# Access Compliance Report

## Public Rights-of-Way

Intersection ID: 10039822	Main Street: TOM_SHORT_RD	Cross Street: N/A	Location: NW
ADA ID: C8F72BEE25BA	Ramp Type: PerpDiag	Initial Pass/Fail: Fail	Overall Compliance: No
		Severity Score: 8.75

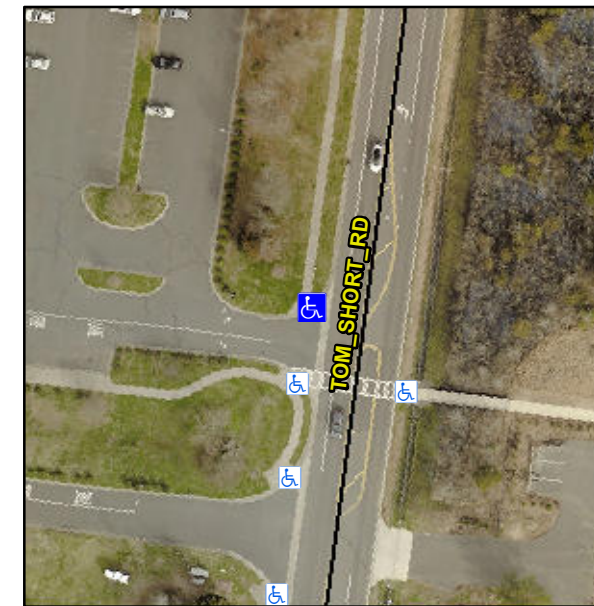
**R304.5.1**

**Remove & Replace Curb Ramp With Two New Directional Ramps or Equivalent.**
